Report on the
Informal mini-review of the CEPC-
SppC Pre-CDR, 13-17 October 2014

M. Koratzinos
FCC-ee ACC meeting,
3/11/2014

Mini-review

Emittance

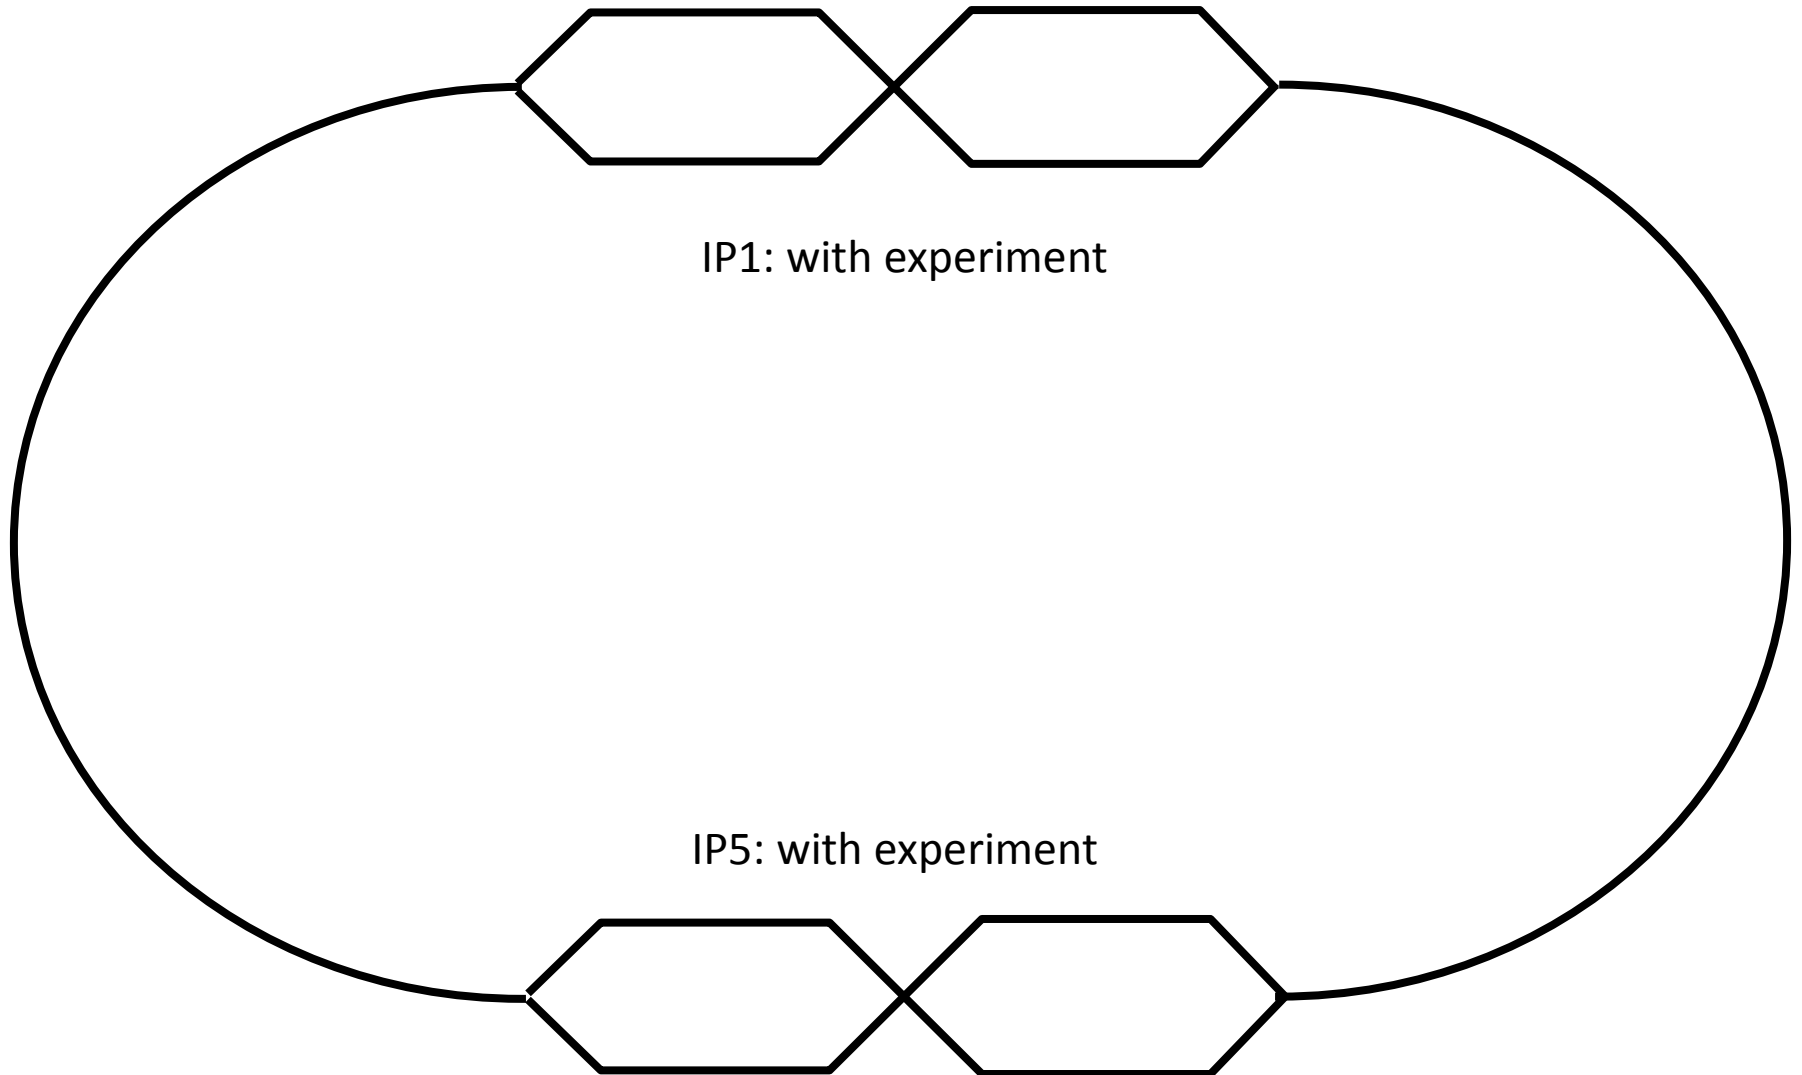
- The ratio of emittances is a (conservative) 330 and it is a matter of strategic choice
- Horizontal emittance is 7 times larger than FCCee (which in turn is a factor of 2 larger than what comes out of MAD)
- Why? Because the ring is twice shorter and FODO cell length about the same.
- Remedy: go from 60 to 90 degree optics to gain a factor of 3
- Go from 48.7m to 38m FODO cell to gain another factor of 2
- This implies some cost increase
